SUBJECT: BEAVER VALLEY POWER STATION, UNIT NO. 2 (BVPS-2) - SUMMARY OF  
CONFERENCE CALL REGARDING THE SPRING 2008 STEAM GENERATOR  
TUBE INSERVICE INSPECTION RESULTS (TAC NO. ME2216)

## SUMMARY OF CONFERENCE CALL

### REGARDING THE SPRING 2008 STEAM GENERATOR TUBE INSPECTION RESULTS

#### BEAVER VALLEY POWER STATION, UNIT NO. 2

**Axial ODSCC:**

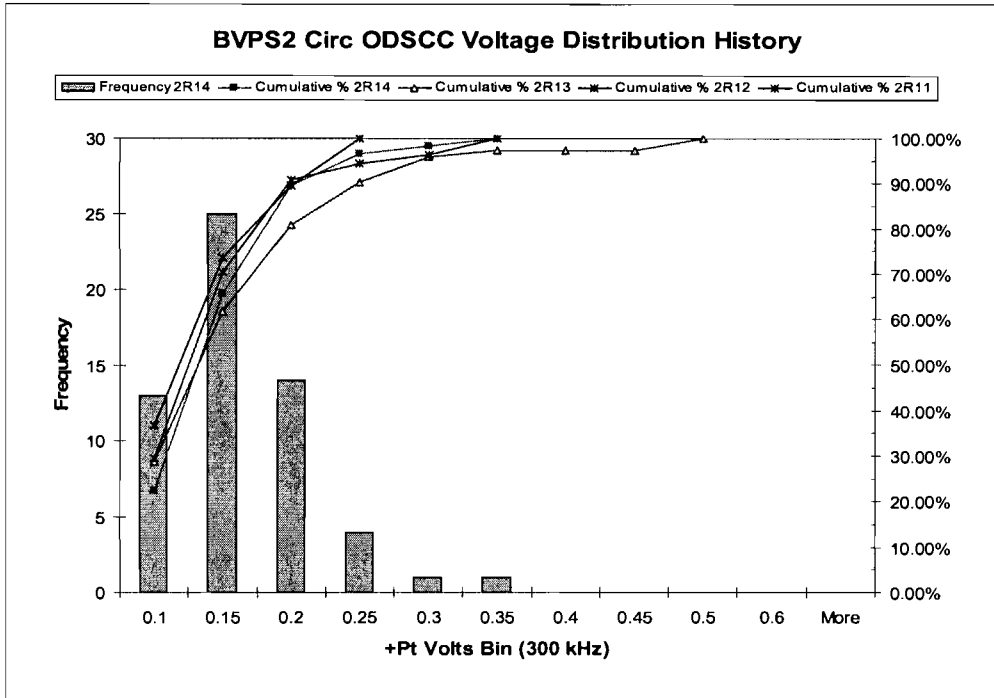
Length: 0.16 to 0.51 inch length, average of 0.30 inch (first pass)  
 Maximum length from profiling is 0.31 inch  
 Voltage: 0.09 to 0.29 volt, average of 0.18 volt (300 kHz)  
 Depth: 39 to 54% TW

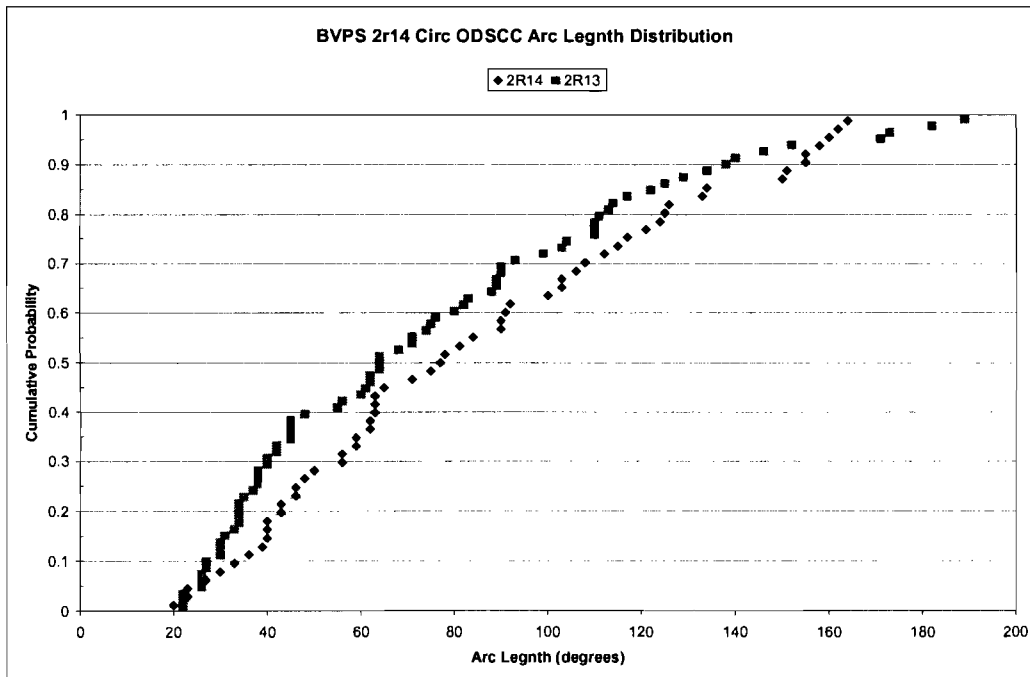
The following figures compare several flaw parameters for the 2R14 and 2R13 outages. The conclusion is that there is no apparent difference in the flaw signals between these two inspections. At 2R13, a top of tubesheet ASCA cleaning process was applied. This reduced the deposit influence at the top of tubesheet and resulted in reduced noise conditions. The 2R14 eddy current data is judged to include a reduced noise level compared to prior outages. The observations that flaw parameters are consistent between 2R13 and 2R14 suggests that the ODSCC aggressiveness condition may have been slightly reduced for Cycle 14 compared to Cycle 13 as the improved noise condition would be expected to result in "larger" flaws at 2R14. The number of tubes affected by SCC at the hot leg top of tubesheet is slightly reduced for 2R14 compared to 2R13.

Long term trending of circ ODSCC +Pt amplitudes shows essentially no change over multiple outages. Therefore it can be concluded that the slight temperature increase associated with uprating has had no discernable effect upon SCC signal amplitude @ 2R14.
